ADDENDUM 01

Roseville Joint Union High School District
West Park High School, Phase 2 – Increment 1
DSA Application Number: 02-118062

DLR Group Project No: 75-19101-00

A1.S1.1

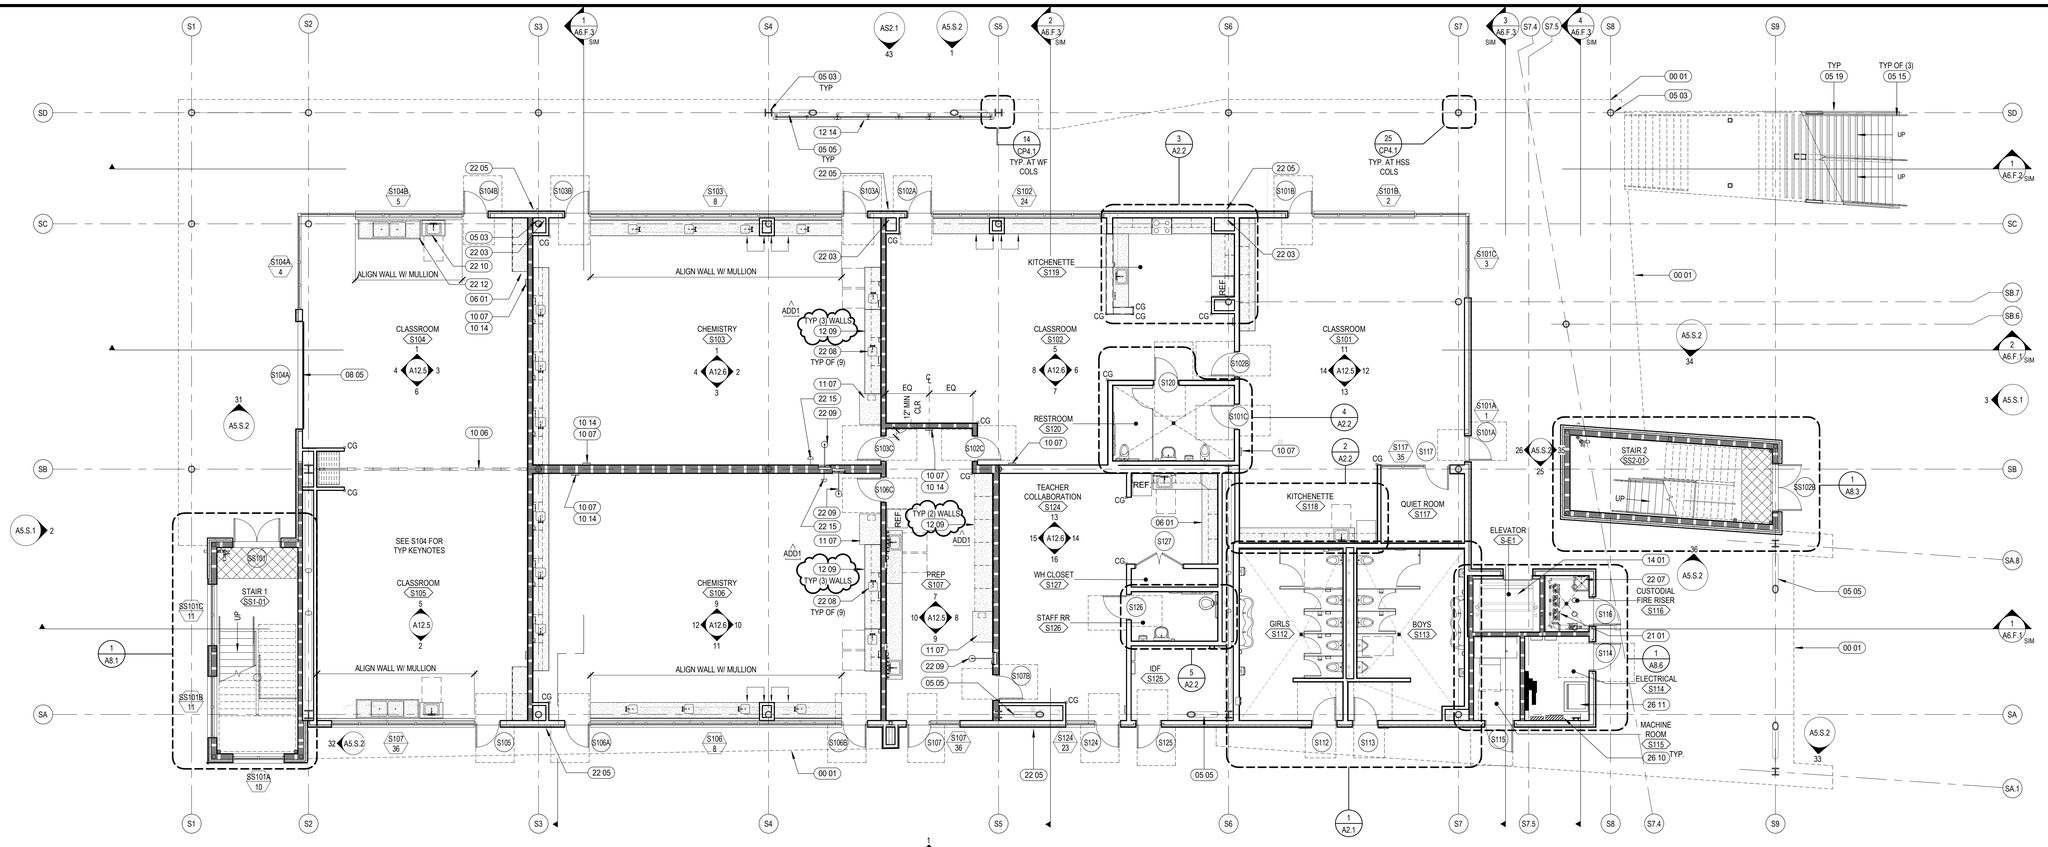
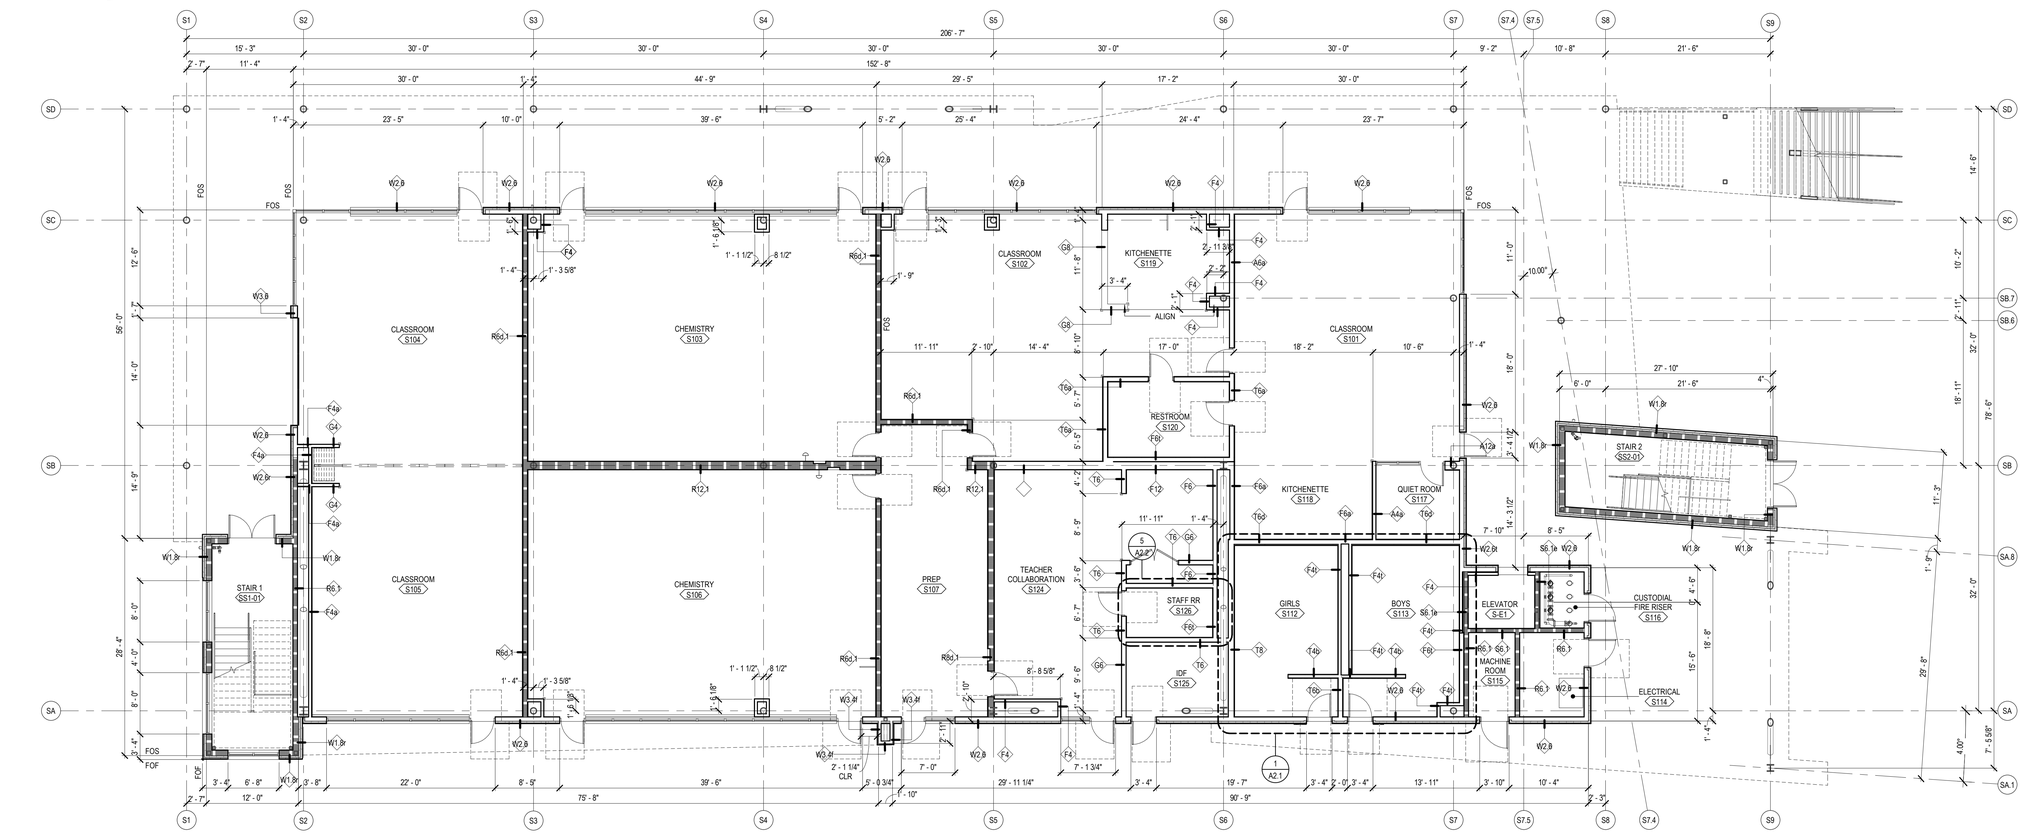
12. **Sheet A1.S1.1 - FLOOR & DIM PLANS – BLDG S – 1ST FLOOR**
    - A. *Floor Plan – MODIFIED keynote 06 01 to be 12 09 Laboratory Casework in Rooms S102, S103, S106 & S107*
    - B. *MODIFIED keynote 22 07 to include detail 51/A10.4 reference*

A3.F2.1

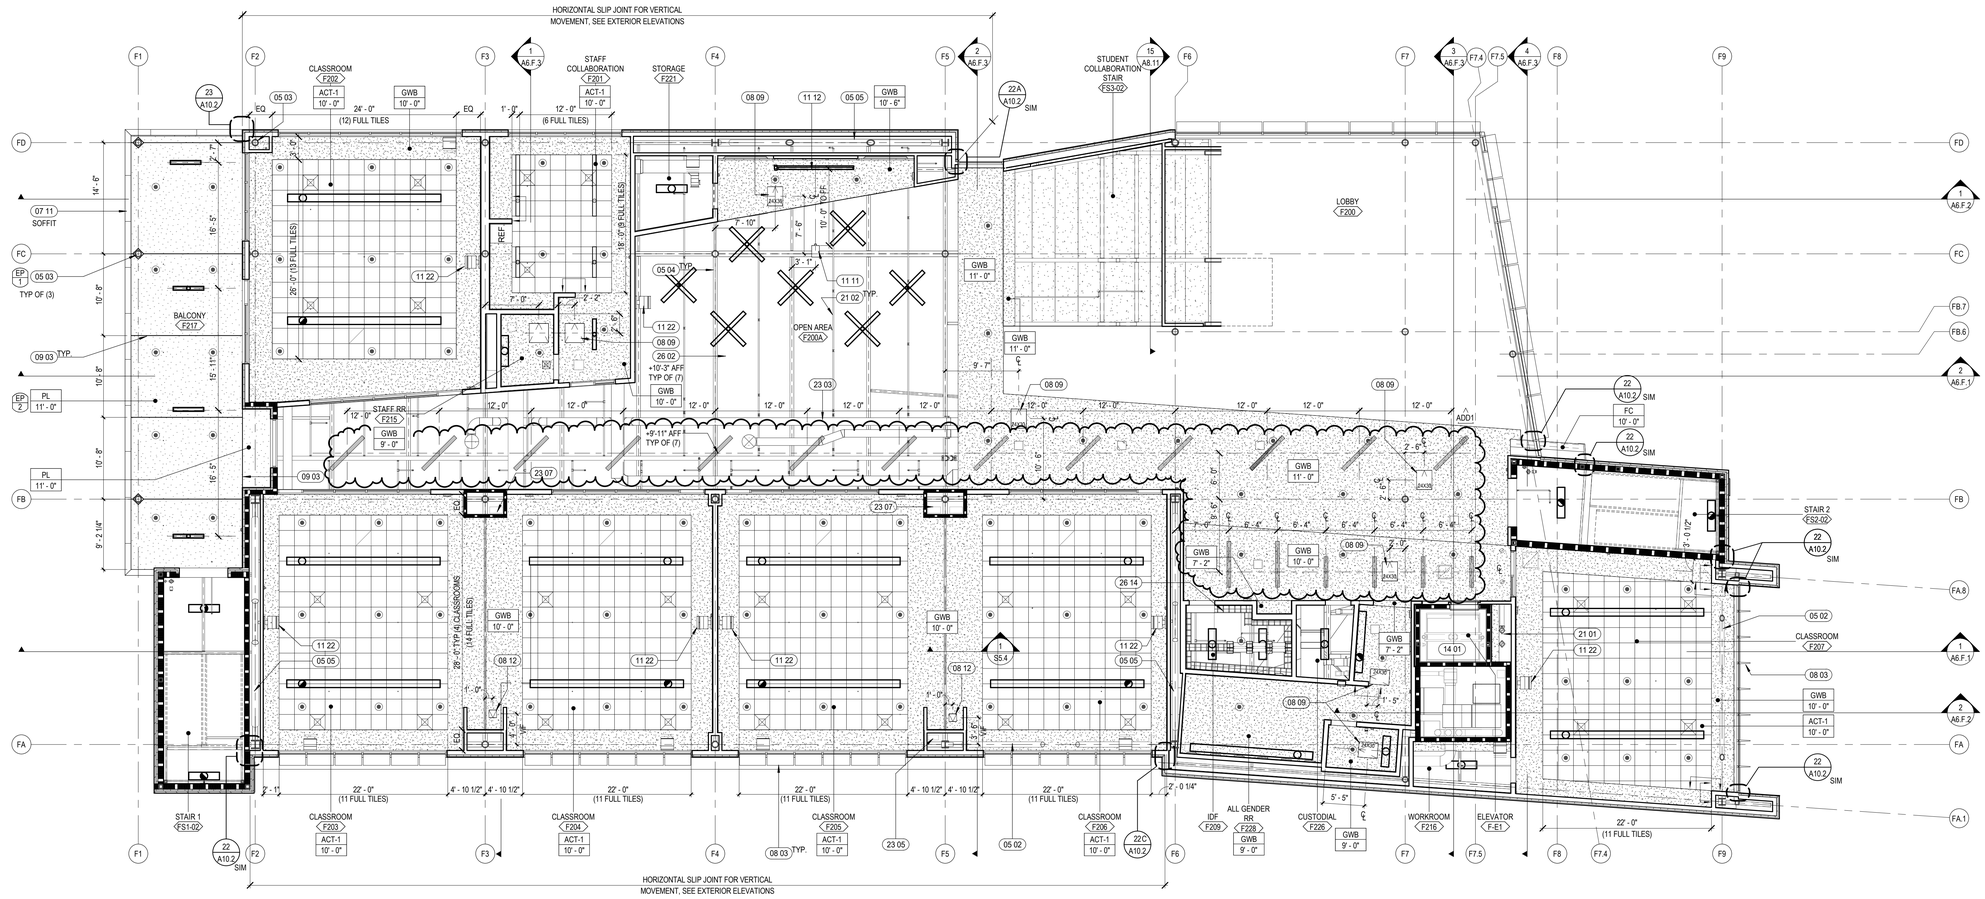
15. **Sheet A3.F2.1 - REFLECTED CLG PLAN – BLDG F – 2ND FLOOR**
    - A. *MODIFIED and dimensioned corridor / open space lighting fixture locations*

REFLECTED CEILING PLAN - BUILDING FOOTHILL - THIRD FLOOR

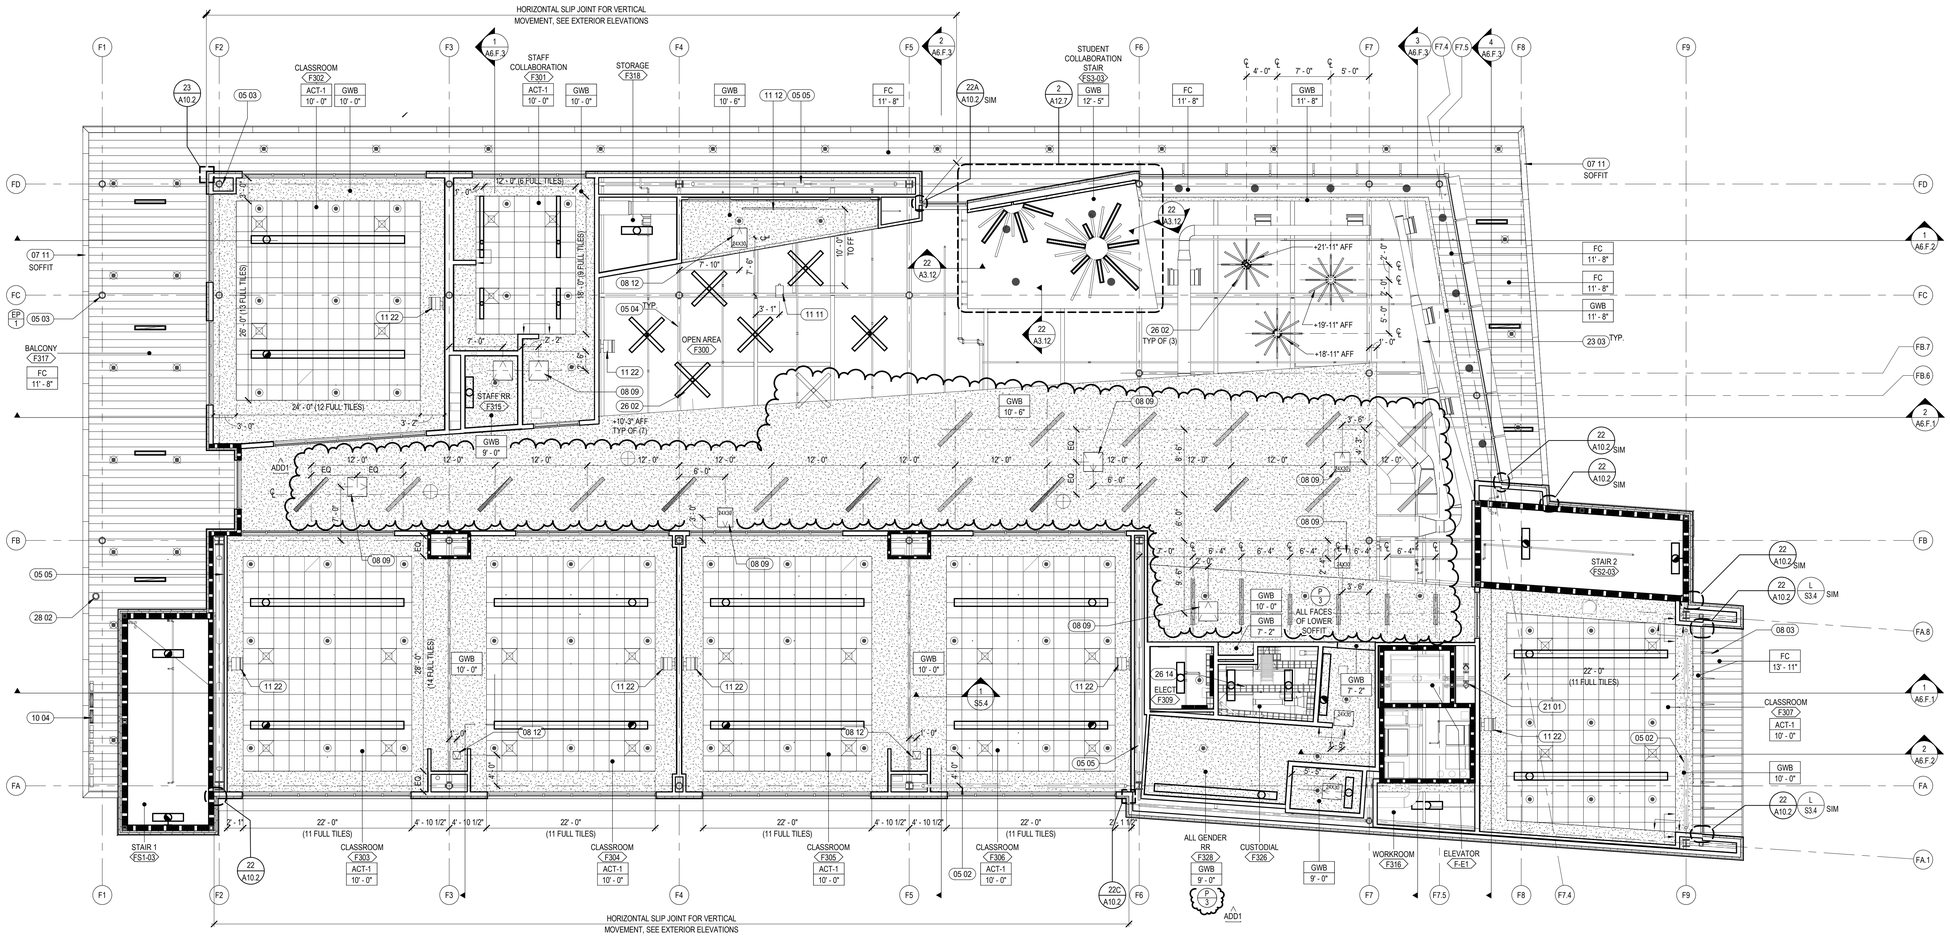
16. **Sheet A3.F3.1 - REFLECTED CLG PLAN – BLDG F – 3RD FLOOR**
    - A. *MODIFIED and dimensioned corridor / open space lighting fixture locations*
    - B. *ADDED paint color to the All Gender RR soffit, as well as the lower soffit outside of the All Gender RR*

A3.S1.1

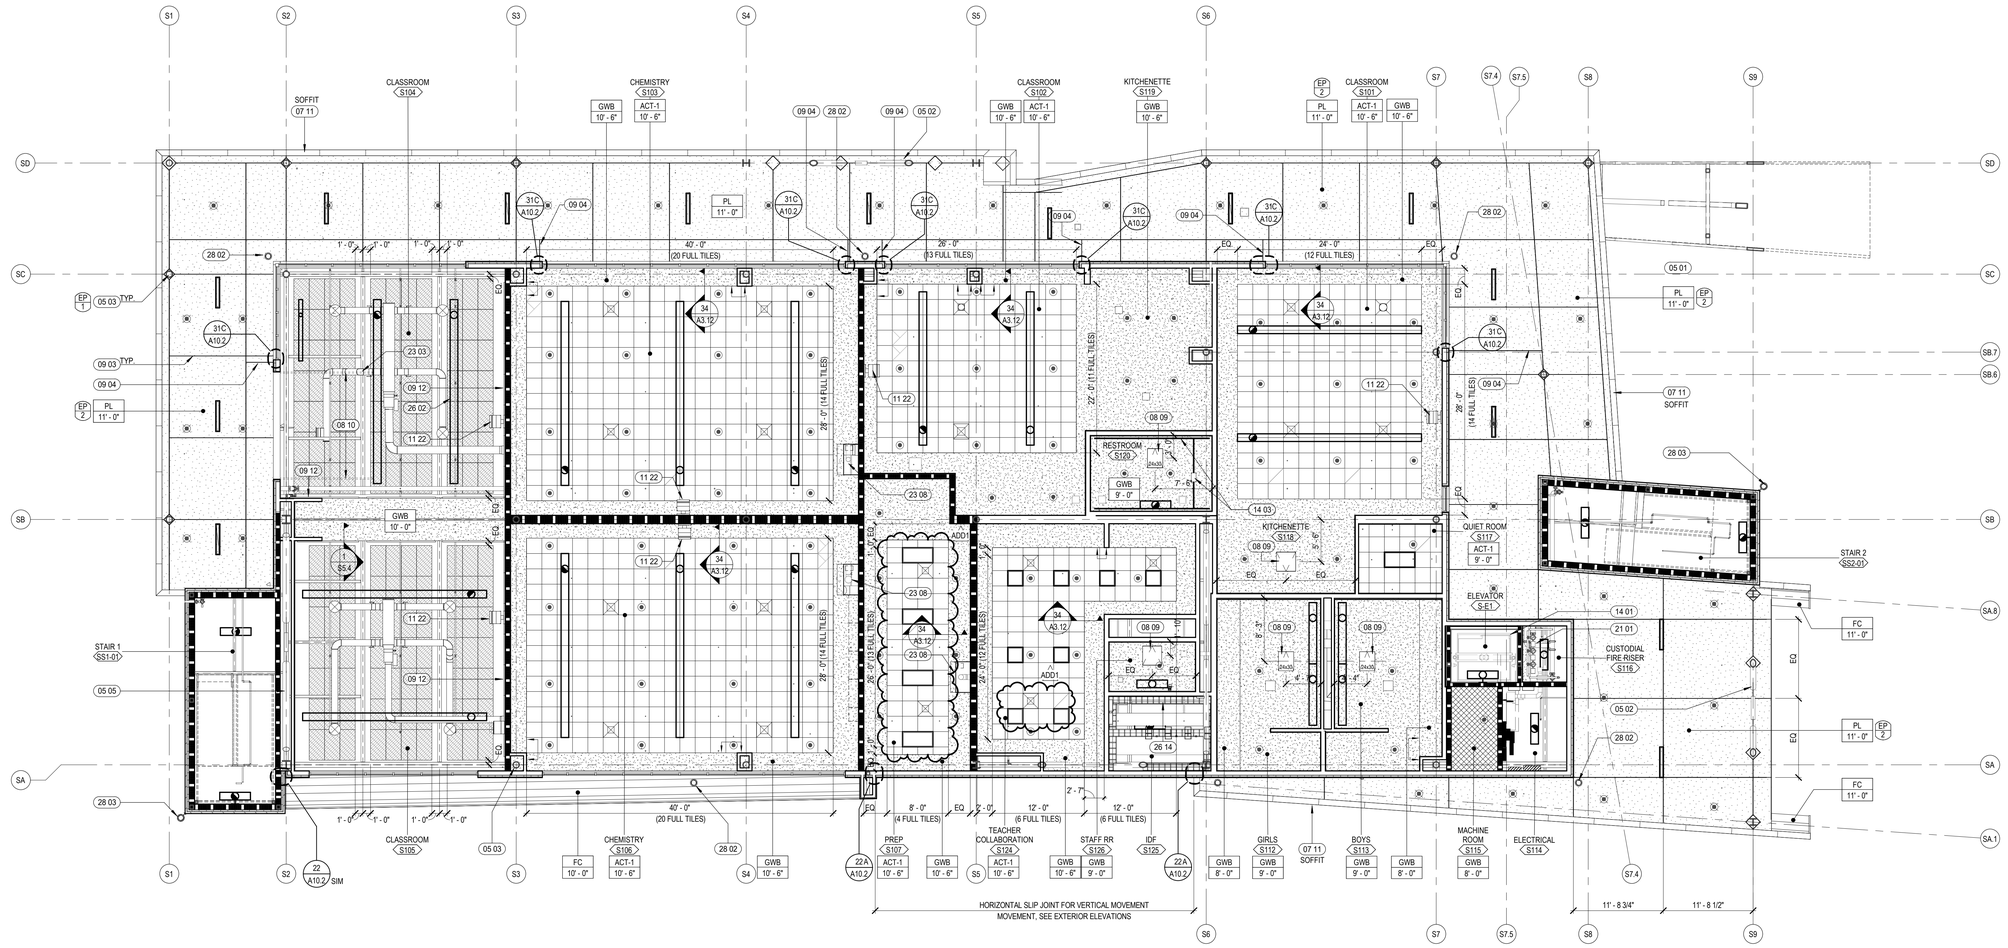
17. **Sheet A3.S1.1 - REFLECTED CLG PLAN – BLDG S – 1st FLOOR**
    A. *MODIFIED Room S107 ceiling grid, lighting fixtures & mechanical grilles configuration*
    B. *MODIFIED Room S124 lighting fixture locations*

A3.S2.1

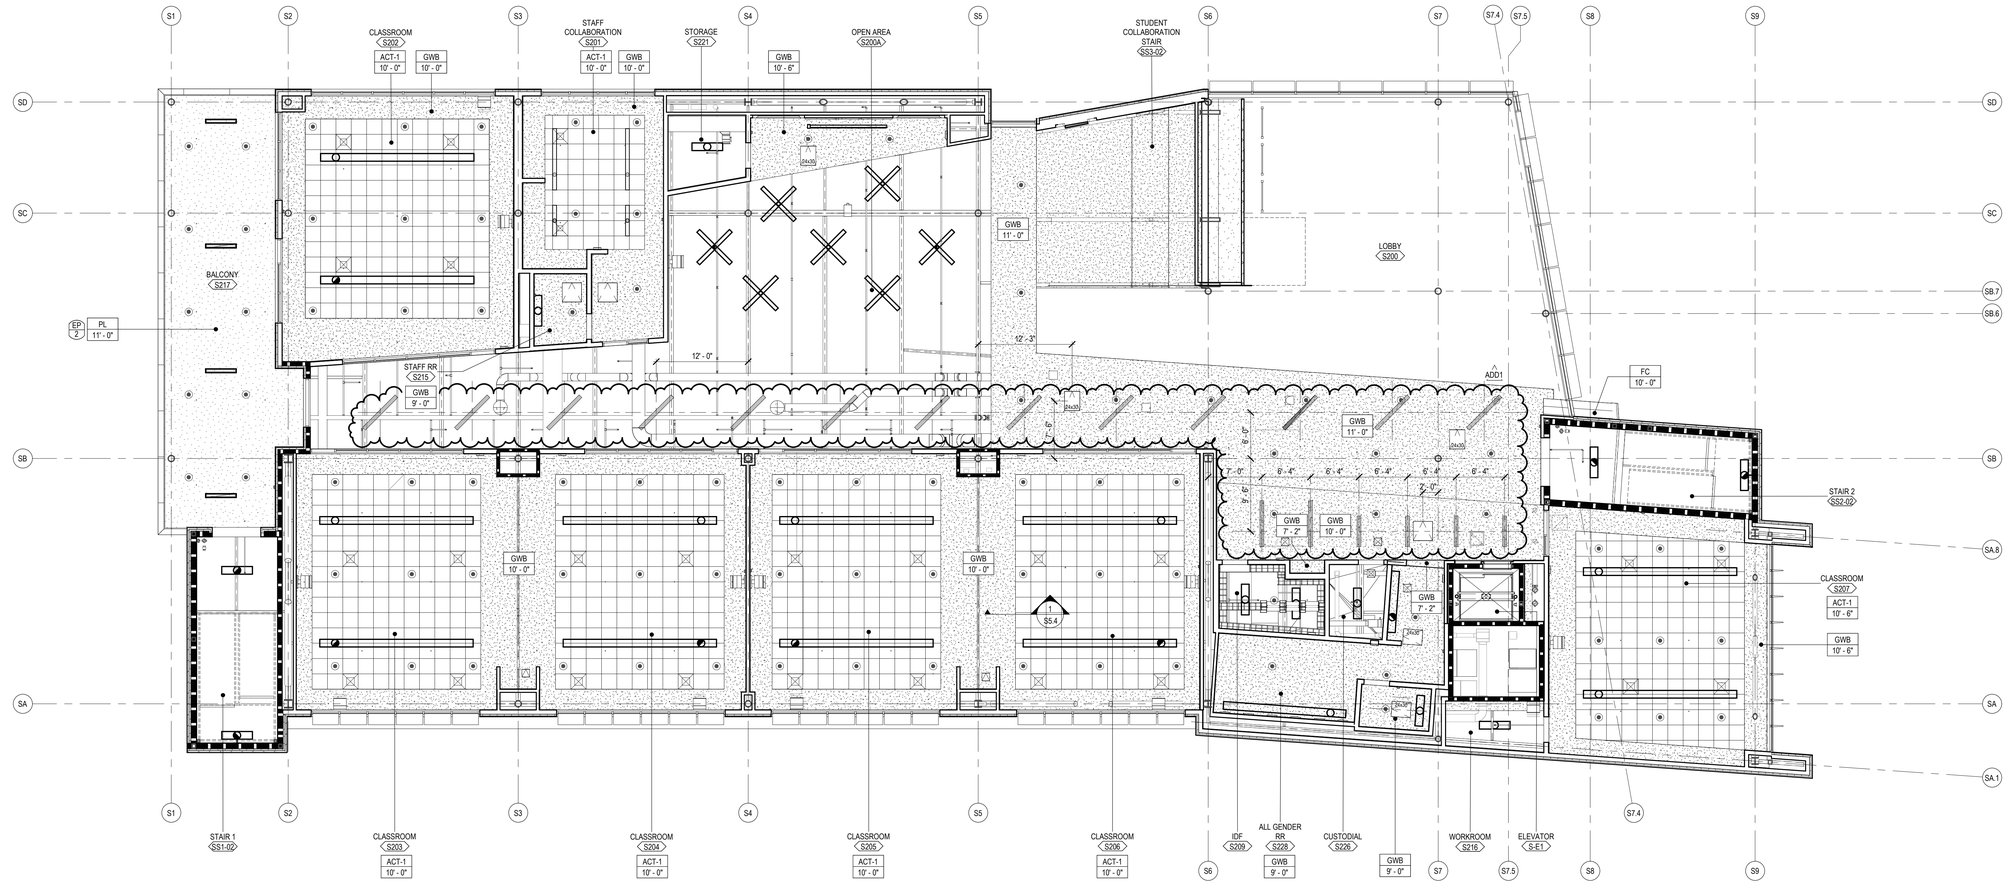
18. **Sheet A3.S2.1 - REFLECTED CLG PLAN – BLDG S – 2ND FLOOR**
    A. *MODIFIED and dimensioned corridor / open space lighting fixture locations*
